Crystal River Nuclear Plant
Docket No. 50-302
Operating License No. DPR-72

Subject: Crystal River Unit 3 – Response to Request for Additional Information to Support NRC Safety Issues Resolution Branch (SSIB) Technical Review of the CR-3 Extended Power Uprate LAR (TAC No. ME6527)

**RESPONSE TO REQUEST FOR ADDITIONAL INFORMATION
– SAFETY ISSUES RESOLUTION BRANCH TECHNICAL
REVIEW OF THE CR-3 EPU LAR**

Figure 1
Proposed Low Pressure Injection System Cross-Tie and Hot Leg Injection Simplified Diagram

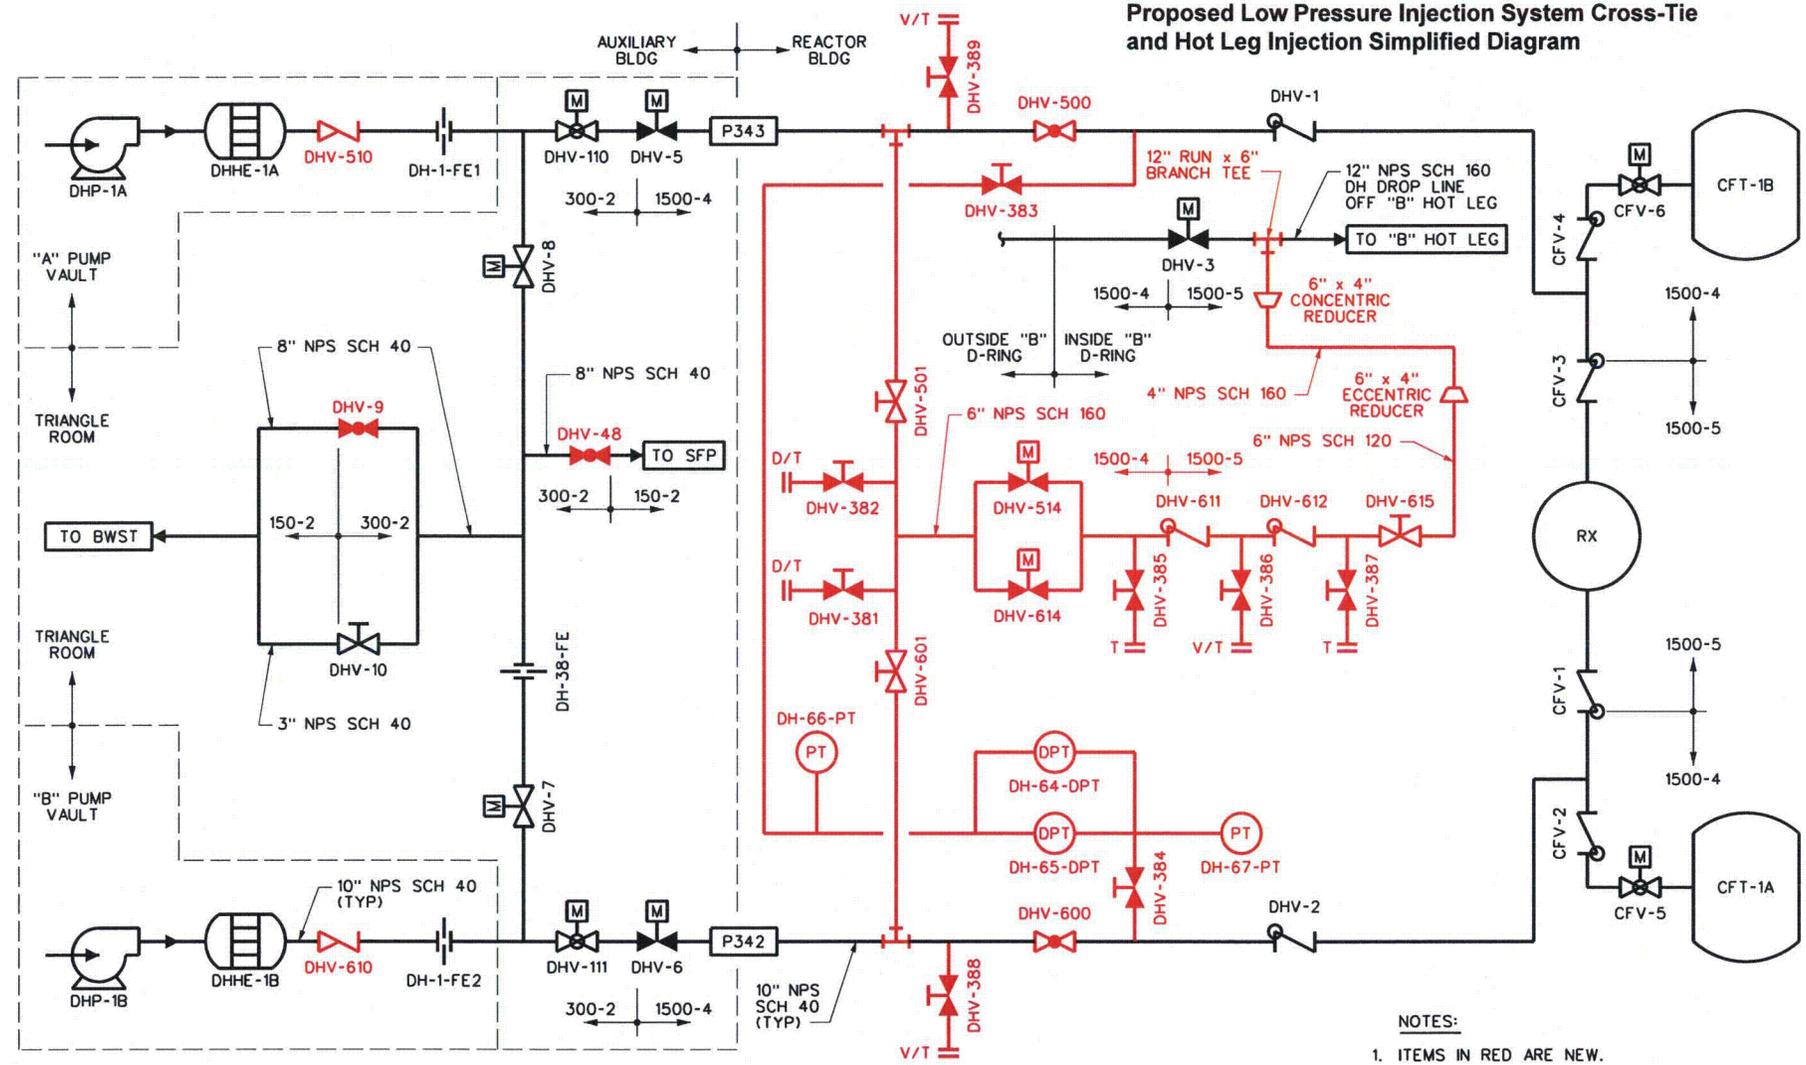
Consistent with the guidance in the NRC staff's safety evaluation on Nuclear Energy Institute [NEI]-04-07, the equipment in the emergency core cooling system (ECCS) and containment spray system, such as pumps and valves, at CR-3 has been evaluated for the effects of debris in the recirculated fluid that bypasses (or passes through) the suction strainers. The power uprate submittal states that valves and piping are being added to the ECCS to support a passive cross-tie between the decay heat removal/low-pressure injection system and reactor cooling system hot-leg B. Please describe the method(s) used to evaluate the new piping system components for blockage and wear and the results of those evaluations.

The new valves for the Low Pressure Injection (LPI) System cross-tie and the hot leg injection (HLI) modification have been assessed for blockage and erosive wear against the wear and plugging criteria of NRC approved topical report WCAP-16406-P-A, "Evaluation of Downstream Sump Debris Effects in Support of GSI-191," (Reference 2). Figure 1, "Proposed Low Pressure Injection System Cross-Tie and Hot Leg Injection Simplified Diagram," illustrates the new valves and instrument sensing lines proposed for installation in the CR-3 LPI System cross-tie and HLI modification.

- Two Flex Wedge normally open, 10 inch gate valves (DHV-501, 601). The valves provide a full port flow path through the cross-tie line. Plugging and wear impact are not considered critical per Section 8.2, "Valves," of WCAP-16406-P-A.

- Two Y-pattern manual 10 inch globe valves (DHV-500, 600). These manual valves will be locked in a throttled position following flow balancing of the system. It is expected that these valves will be throttled approximately 50% open to establish at least 3000 gpm. FPC has assessed the plugging and wear impact of these valves and concluded that adequate margin exists to account for fine tuning of the valve throttle position during flow balancing. These valves will meet the plugging and wear acceptance criteria of Sections 7.3.3, "Flow Area Evaluation for Plugging and Wear," and 7.3.2, "Erosive Wear," of WCAP-16406-P-A, respectively.

- Two Y-pattern globe style, 10 inch stop check valves (DHV-510, 610). These valves will change position based on pump discharge flow and prevent reverse flow through an idle pump, if necessary. Since these check valves are > 1 inch, and the minimum required flow through the valves is normal LPI System flow (i.e., > 0.42 ft/sec), plugging and wear impact are not considered critical per Section 8.2 of WCAP-16406-P-A.

- Two normally closed motor-operated, parallel slide, 6 inch gate valves (DHV-514, 614). The valves are required to open in certain post-accident scenarios to support boron precipitation mitigation in the core. These gate valves are > 1 inch and are either fully open or fully closed; thus, plugging and wear impact are not considered critical per Section 8.2 of WCAP-16406-P-A.

- One manual normally open, 6 inch Flex Wedge gate valve (DHV-615) provides a full port flow path through the new HLI line. This gate valve is > 1 inch and is normally fully open; thus, plugging and wear impact are not considered critical per Section 8.2 of WCAP-16406-P-A.

- Two normally closed, 6 inch, nozzle check valves (DHV-611, 612) will open to pass process flow in certain post-accident scenarios to support boron precipitation mitigation in the core. Since these check valves are > 1 inch, and the minimum required flow through the valves is 400 gpm (i.e., > 0.42 ft/sec), plugging and wear impact are not considered critical per Section 8.2 of WCAP-16406-P-A.

- Two normally closed, 8 inch, T-pattern, manual globe valves (DHV-9, 48) in the process lines to the spent fuel pool and the borated water storage tank. These normally closed test valves are > 1.5 inches; thus, plugging and wear impact are not considered critical per Section 8.2 of WCAP-16406-P-A.

- The new LPI System pressure instruments (DH-64-DPT, DH-65-DPT, DH-66-PT, and DH-67-PT) utilize 0.5 inch, stainless steel tubing for impulse sensing lines to connect to the LPI System piping downstream of throttle valves DHV-500 and DHV-600. Since the impulse sensing instrument lines are static fluid lines and have no discernible flow, the only credible

method causing the instrument sensing lines to become plugged would be caused by settling debris in the lines. Therefore, the LPI System cross-tie line modification design includes connecting the 0.5 inch sensing line perpendicular to the main 10 inch LPI System piping at the pipe horizontal center-line, which will ensure the sensing lines remain water-solid minimizing the possibility of debris entrapment and settling in the sensing lines. Thus, the LPI System pressure impulse sensing line design meets the criteria specified in Section 8.6.6, "Sensing Line Evaluation," of WCAP-16406-P-A.
